Planning and Zoning Commission	AGENDA # _____
	STAFF REPORT

MEETING DATE: June 4, 2015

Request by Design Results, LLC on behalf of Piyush Patel, for the following land use approval on 1.8 acres of land otherwise known as 804 N Cacheris Court (APN: 505-23-001U) within the Casa Grande Corporate Center Planned Area Development (PAD) (Planner James Gagliardi):

- 1. DSA-15-00021: Major Site Plan/Final Development Plan** for development of an 11,370 sq. ft. Boston's Restaurant and Sports Bar.

Exhibit C – Landscape Plan

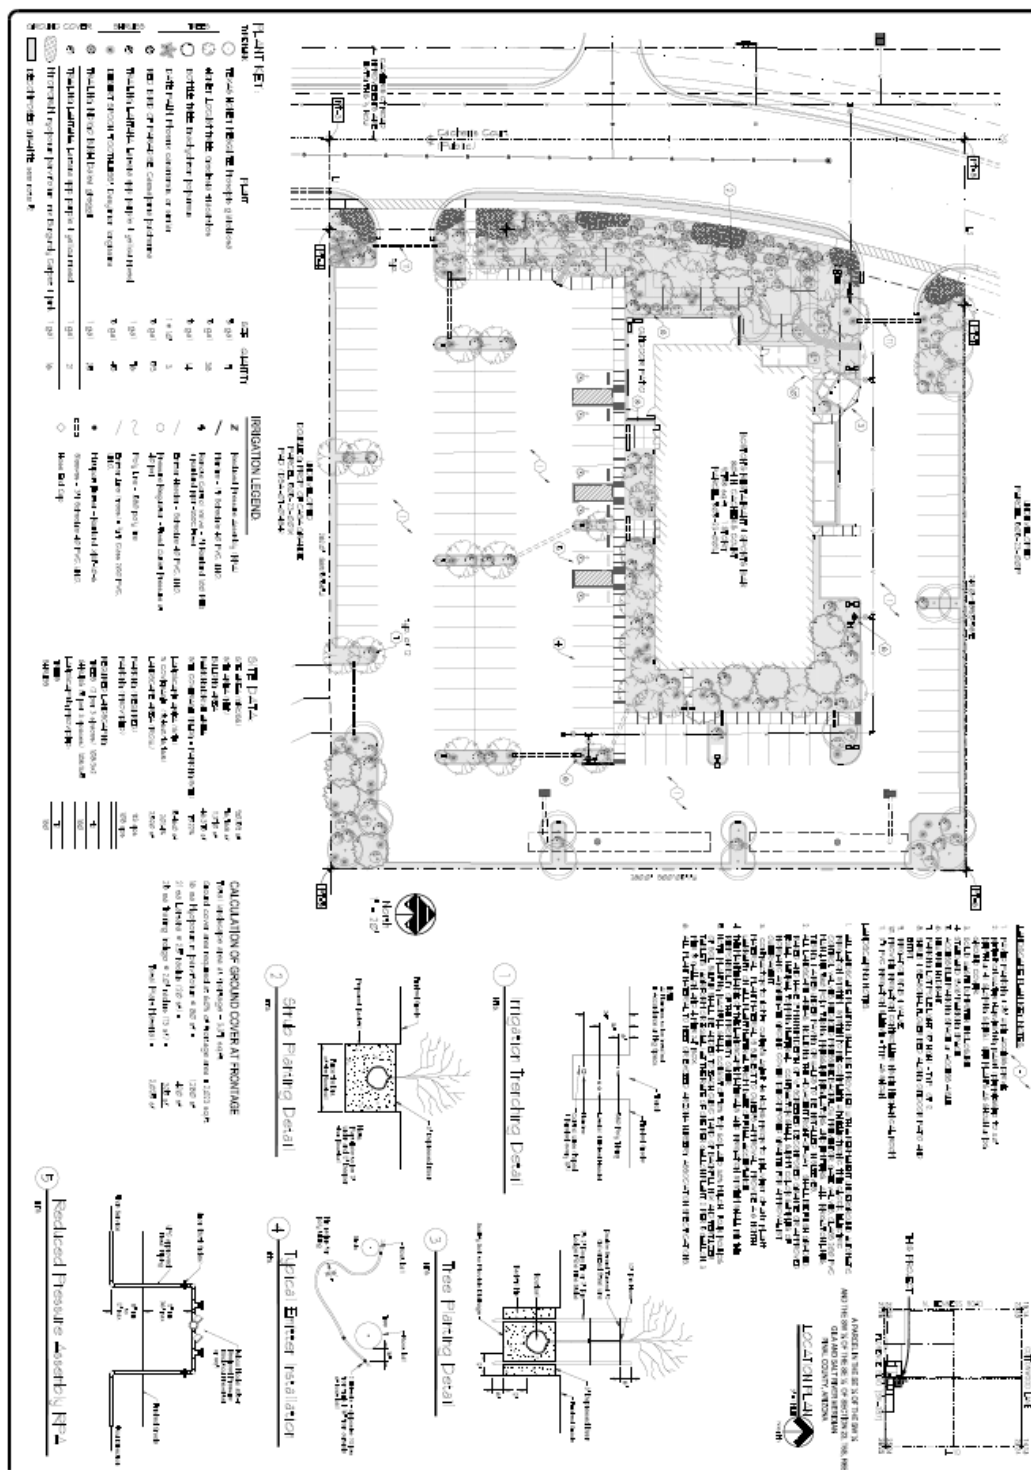
A landscape plan was provided and found to meet the landscaping criteria as set forth in the Article VI of 17.52 of the City Code (Exhibit C). The final landscape plan will be reviewed in conjunction with the review of the building permit. Commercial sites require two trees and five shrubs for every three parking spaces. 108 parking spaces are to be provided with 72 trees and 180 shrubs being provided as required. Landscape islands are also sufficiently provided, with landscaped islands provided every ten parking spaces. This site also provides a landscape area of 20.4% where only 10% is required. A landscape buffer ranging from 15 ft. to 32 ft. has been provided adjacent to Cacheris Court.

Exhibit D- Photometric Plan

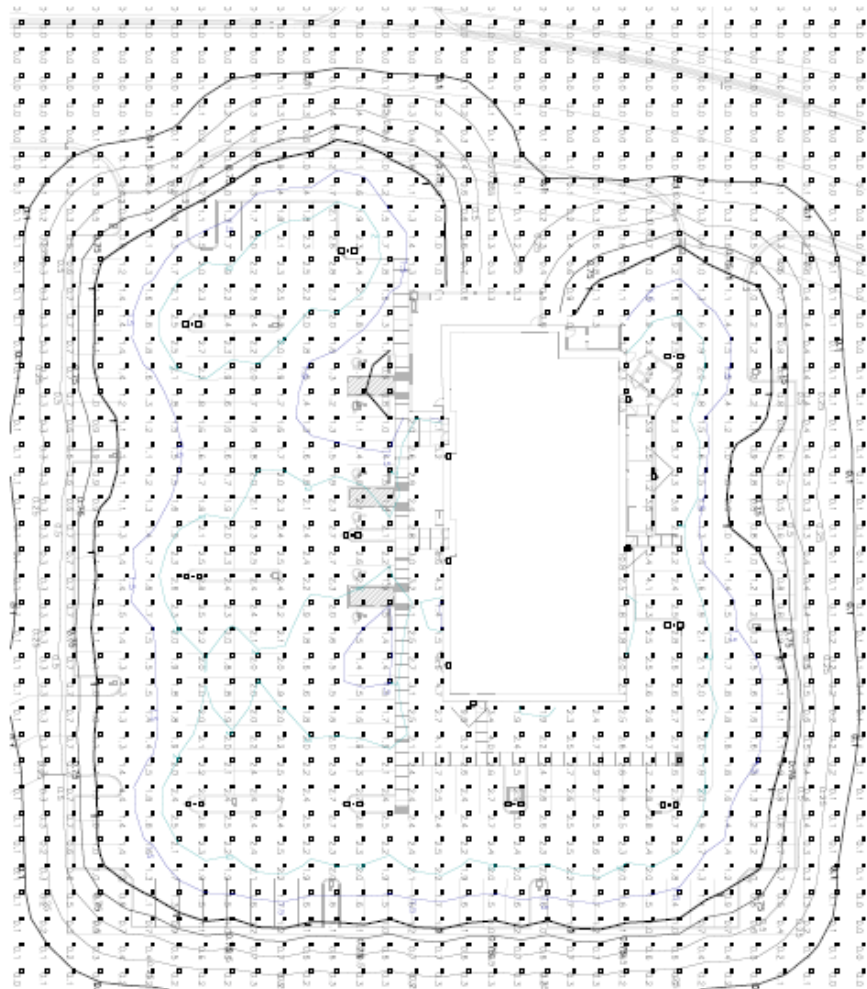
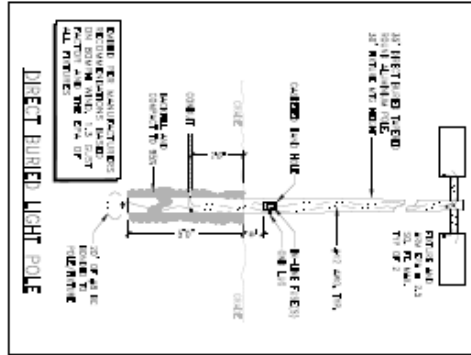
A photometric plan has been submitted showing no bleed of light onto other sites (Exhibit D). Per the PAD, light poles cannot exceed 25 ft. in height. The photometric plan however, shows 35 ft. tall poles. As a condition of approval, the poles are not allowed to exceed 25 ft. in height. A revised photometric plan shall be provided detailing that reduction.

1. Map of Dedication must be approved by City Council and recorded prior to issuance of a building permit.
2. Modify the light standard detail on the photometric plan to reduce the height from 35 ft. to 25 ft.
3. Revise Drainage Report and Plan where applicable to show the following:
 - The basis of Runoff Coefficient C for Pervious area is 0.7 (Desert lawn or rock lawn) per City Code 15.40.1290. Please Revise. A weighted runoff coefficient for a substantially paved site like this is needed for final drainage analysis.
 - Rainfall intensity is related to time of concentration. Refer to Rational Method methodology provided in Pinal County Drainage Manual or Maricopa County Drainage Design Manual (Hydrology) for peak flow calculations and revise the drainage design (hydrologic and hydraulic)
